Comments on revised plans and drawings with Planning Application 2023/61/93714/E

[2023/61/93714/E](#)

Land off, Cumberworth Lane, Denby Dale, Huddersfield, HD8 8RU

Reserved Matters application (including the consideration of access, appearance, landscaping layout, and scale) for the erection of 10 dwellings pursuant to outline permission 2019/93906 for erection of residential development up to 10 dwellings, and discharge of condition 20 (waste arrangements)

Part copy of 1041447 17/05/2024:

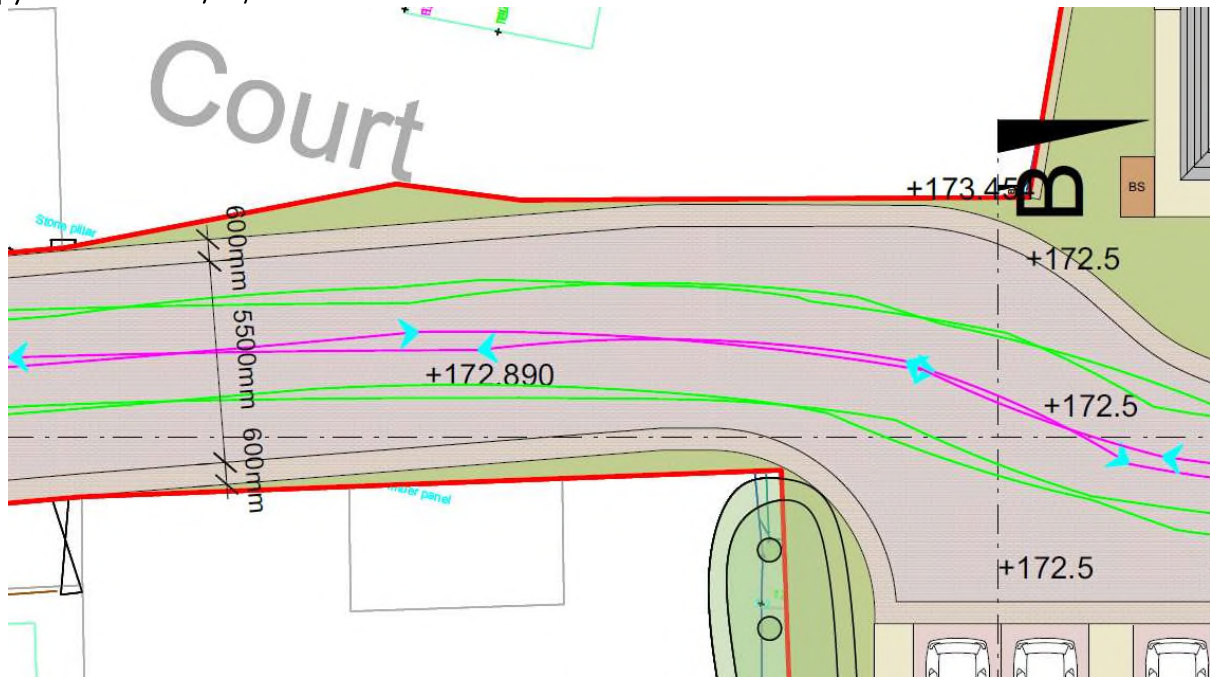
Comparing [Proposed Site / Block Layout \[id 1041447\]](#) 17/05/2024 10D with the previous version [Proposed Site / Block Layout \[id 1031055\]](#) 29/02/2024 10C, it can be seen that the width of the access roadway has been increased up to the indicated boundary lines and width dimensions have been added, $2 \times 600 + 5500 = 6700 \text{ mm}$ total. I think this dimension is inaccurate and misleading in that it does not show the narrowest part of the roadway, which is at the existing gate to the field. My own measurements at the gate indicate that only **4800 mm** total width is available at this point.

I believe that the boundary line to the south of Cruck Cottage, shown in red on these drawings, is not depicted accurately. Referring to the more detailed plans submitted with the 2019 application, [Grouped Plans and Elevations \[id 846469\]](#) 16/10/2020 - Updated Highways Plans, it can be seen that the boundary line depicted is inside the existing gate, fences and stone wall associated with Cruck Cottage.

It appears that the access roadway shown on the latest plans would impinge on the existing boundary of Cruck Cottage and indeed extend beyond the existing gate, fences and stone wall that are associated with this property. It is recommended that the site be visited and the dimensions and actual boundary location independently checked by the Planning Officer.
